City of Rockport

CITY COUNCIL REGULAR MEETING AGENDA

18. Consider the approval of Construction Change Directive #4 related to the new City Hall project

Consider the approval of Construction Change Directive #5 with Teal Construction related to the new City Hall project (cost pending)

WINDOW HEAD/ ARCHED EIFS PANEL SILL DETAIL - DEMO 3" = 1'-0" 4

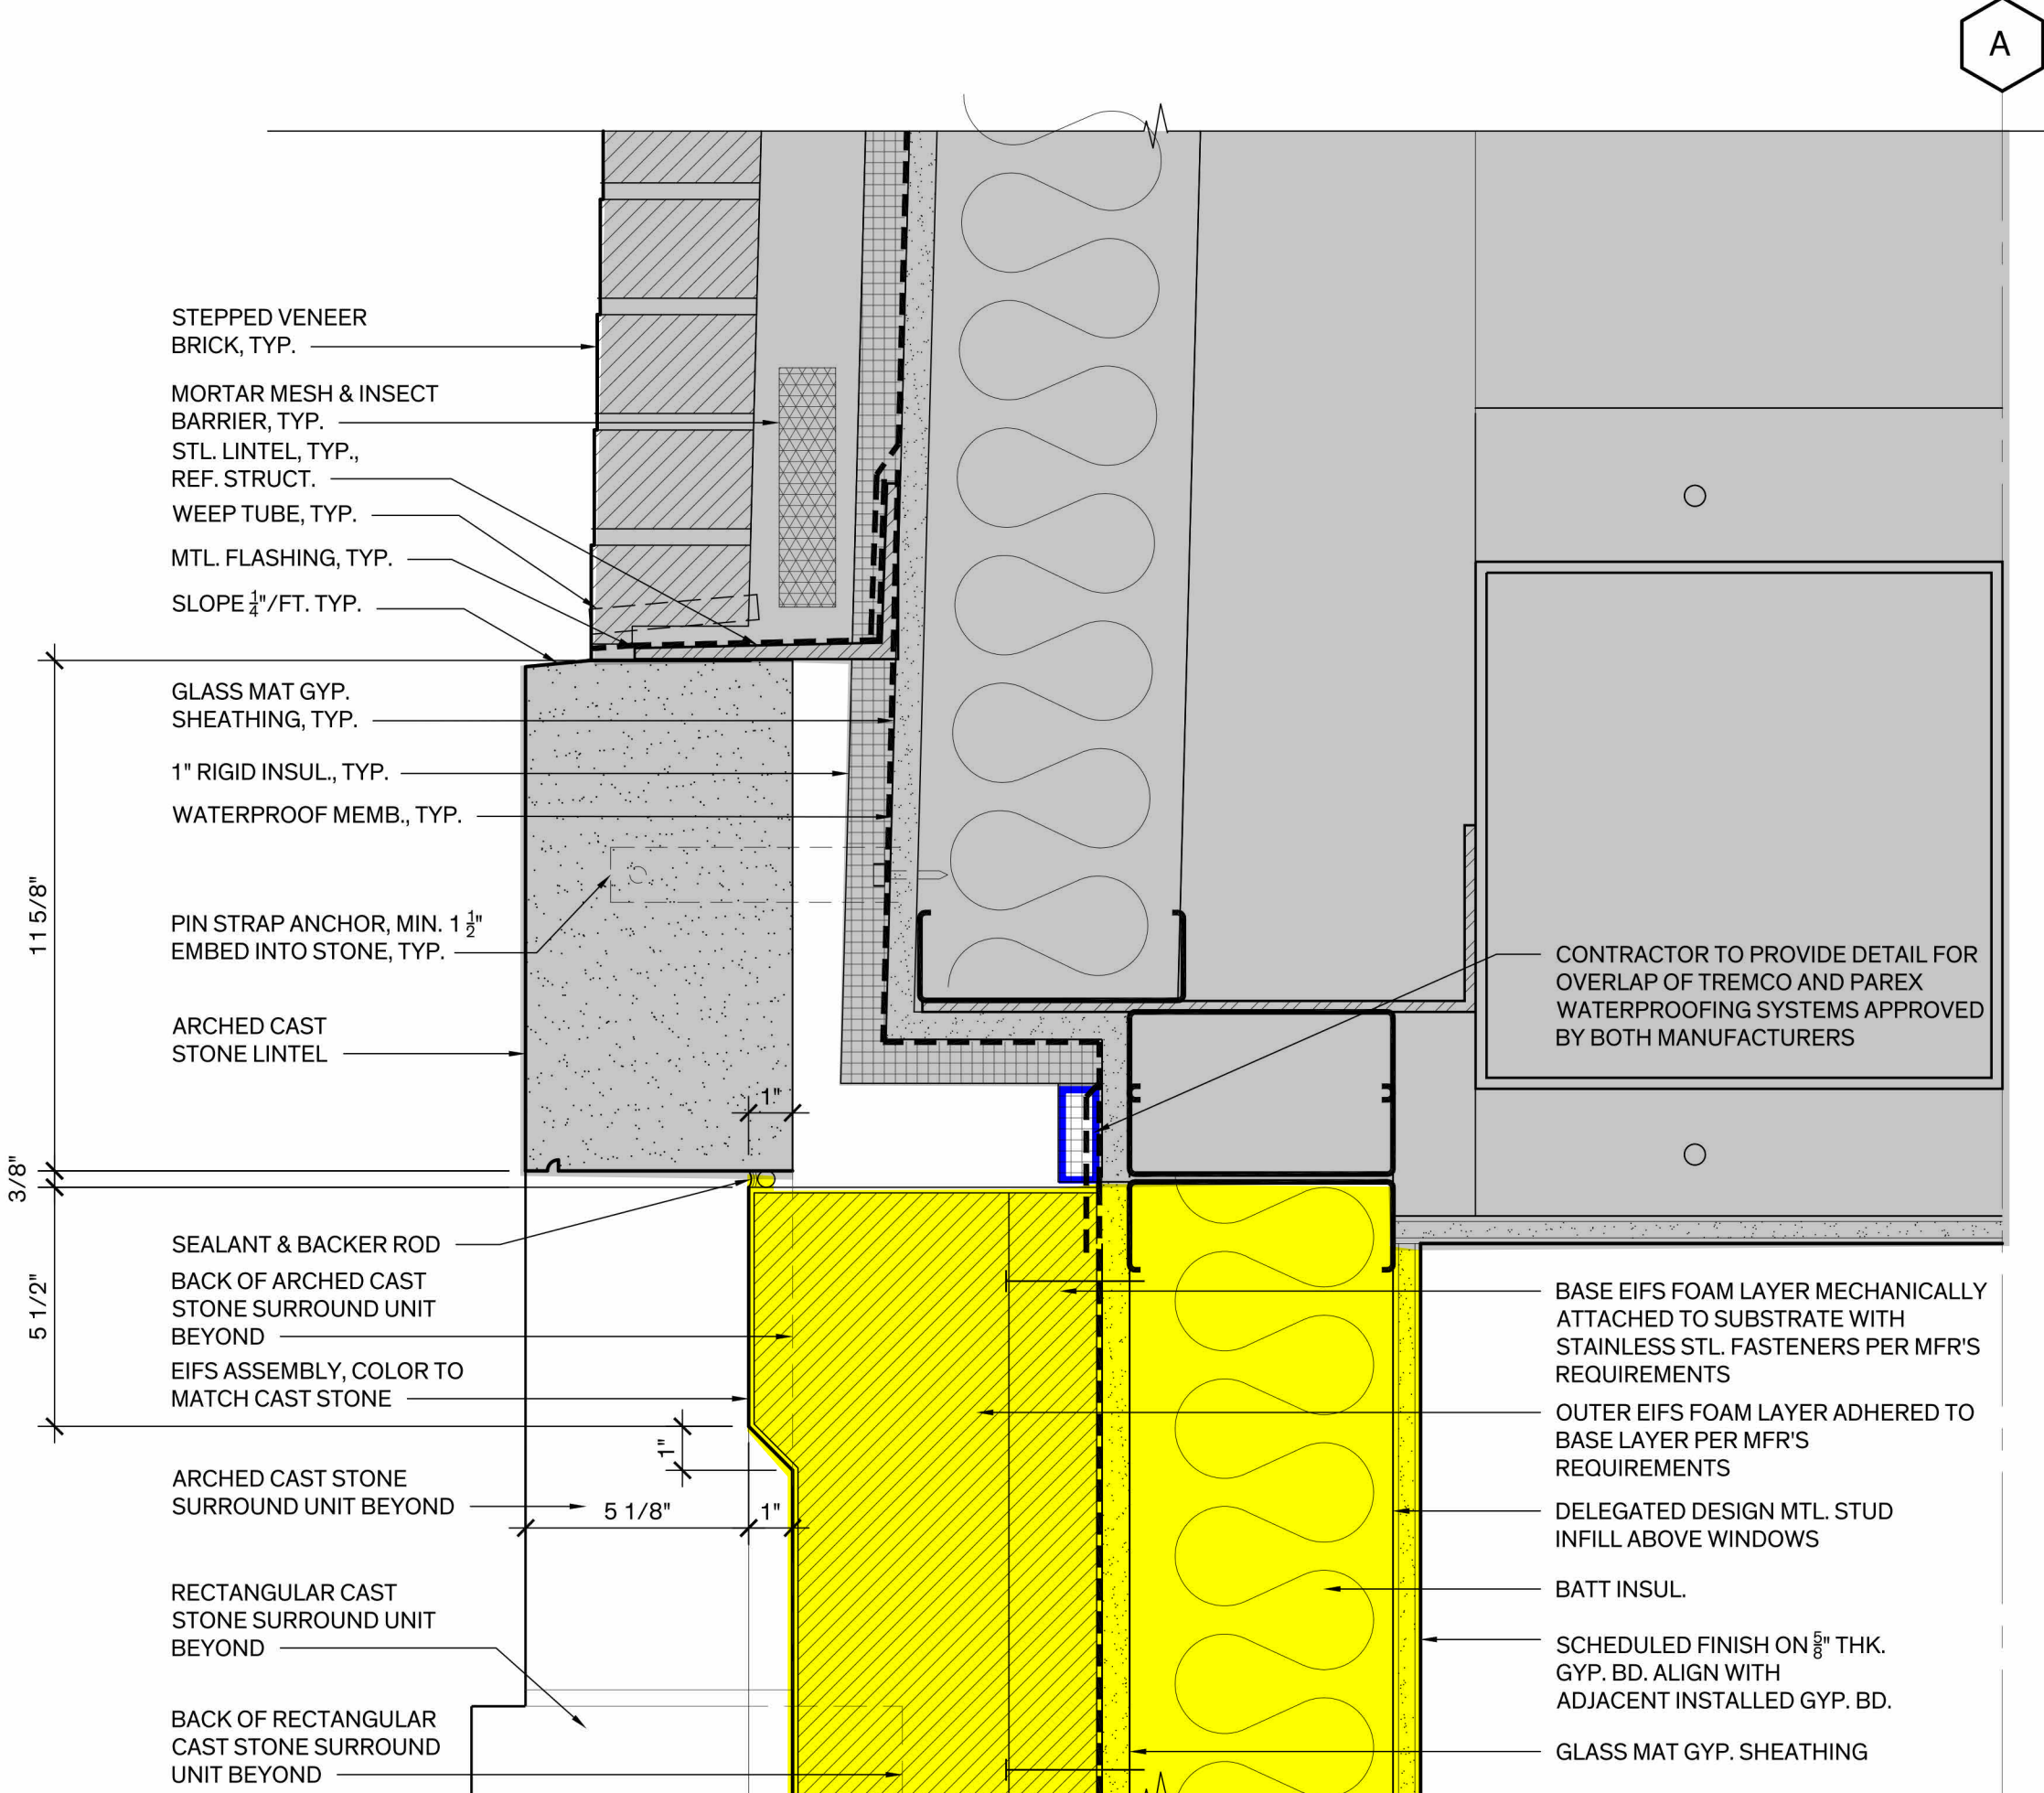
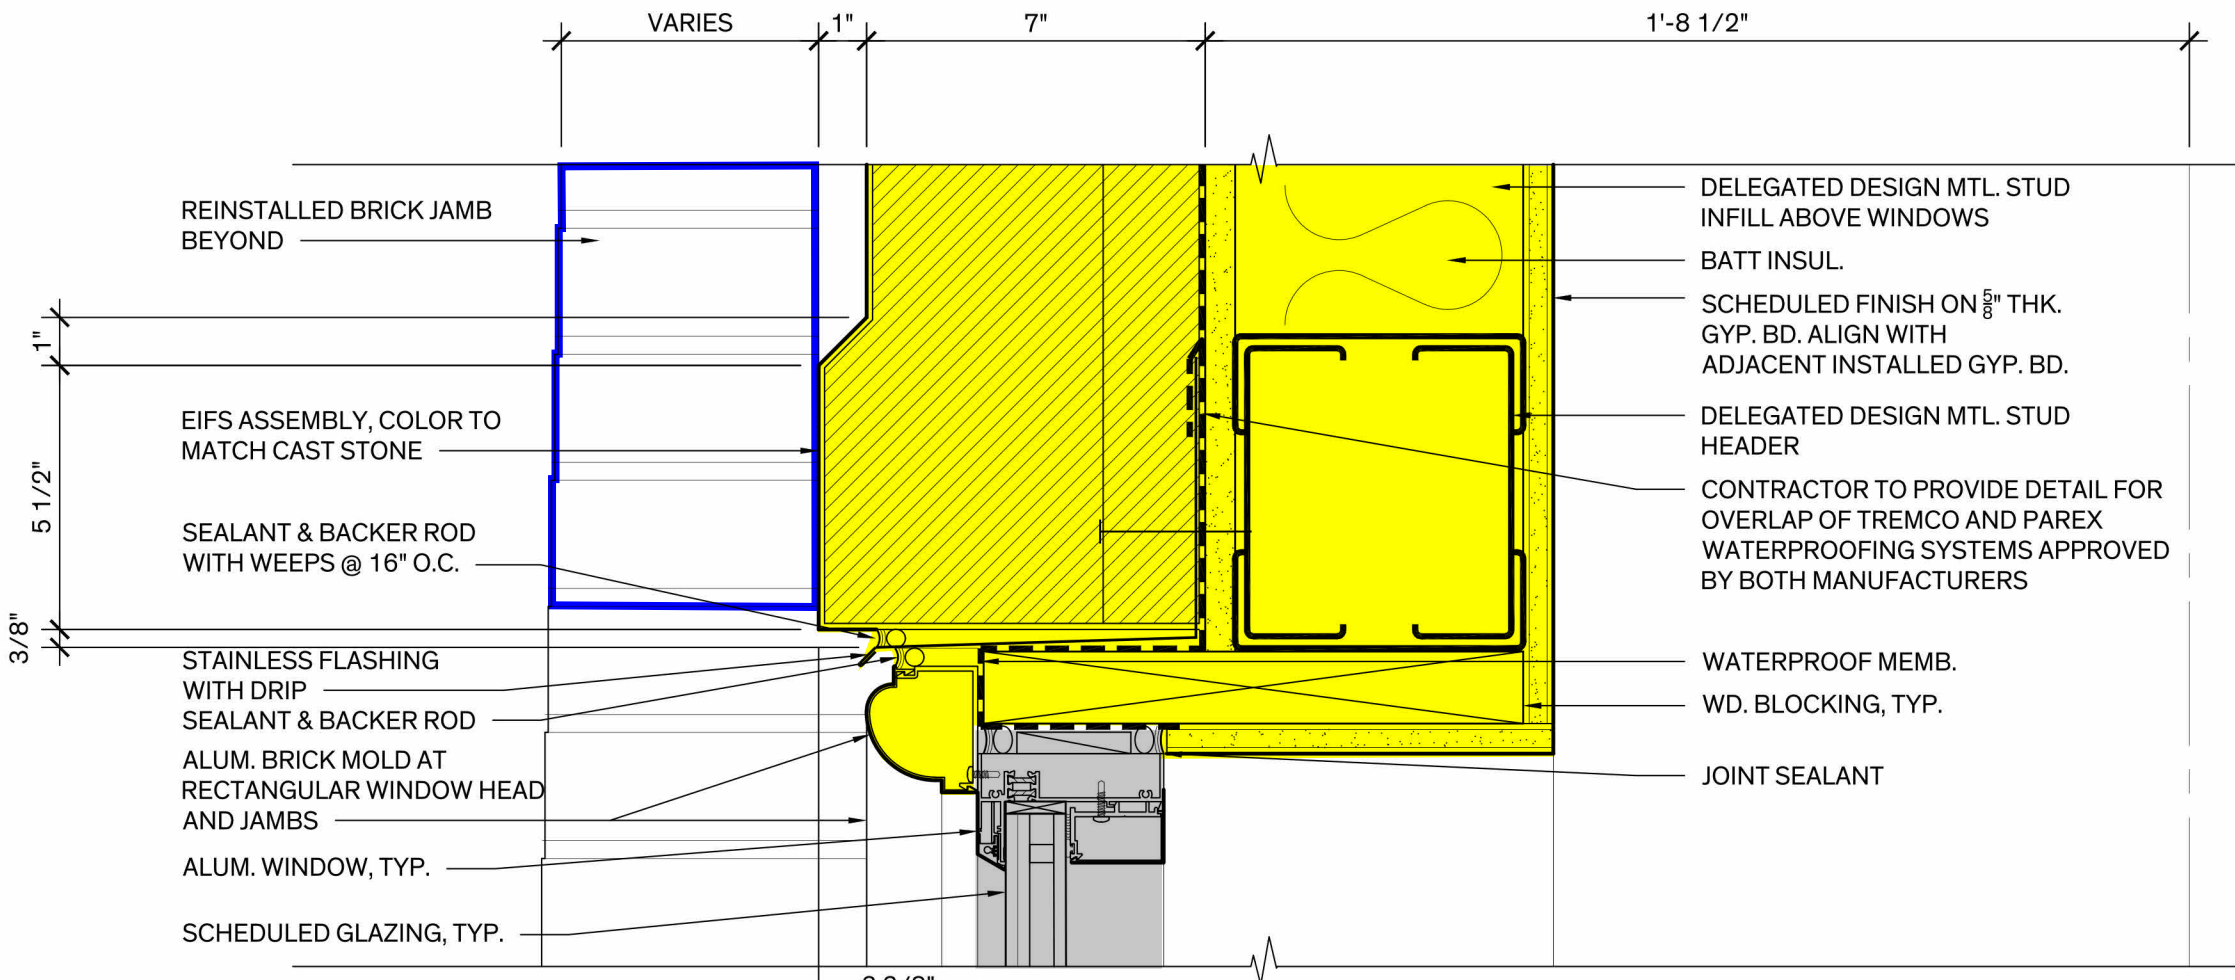
Special infill/reworking of as-built conditions is now required for areas that should have been incorporated with the surrounding metal framed walls per direction provided well in advance of metal framing installation. Had these changes been properly coordinated by the General Contractor, the change in material and labor would have been negligible, especially given the elimination of arched framed openings, etc. Teal is therefore responsible for all metal framing costs associated with this change request.

-The change from full height arched to reduced height rectangular windows with metal framed wall and decorative panels above was made during window shop drawing review dated 11/22/22. Teal did not coordinate the change with other affected subcontractors.

-The area was further documented in RFI 82 dated 2/7/23, see SK-3A through 3D.

-Architexas noted the missing framing and window head for the rectangular window openings in metal framing shop drawing review dated 2/22/23.

-Construction of metal framing and window openings proceeded in conflict with design team direction. Architexas noted the incorrectly built window framing in Field Report 12 from site visit on 1/3/24 and referred back to RFI 82.

-Teal continued construction of the tower exterior envelope and window openings with incorrect conditions and did not issue RFI 168 until 7/16/24.

-Teal did not coordinate the infill panels designed for the area above the rectangular windows (SK-1 provided 11/22/22 with window shop drawing review) and sequencing of surrounding construction. Infill panels needed to be coordinated prior to proceeding with waterproofing and finished masonry openings. Teal is responsible for all masonry removal and reinstallation required in this change request.

Provide EIFS infill with recessed panel detailing within arched openings above tower windows. Refer to attached revised SK-3A, SK-3B, SK-3C, SK-3D, and new SK-3E.

REMOVE
AS-BUILT TO REMAIN
INFILL REQUIRED AT EIFS PANELS
REINSTALL REMOVED COMPONENTS
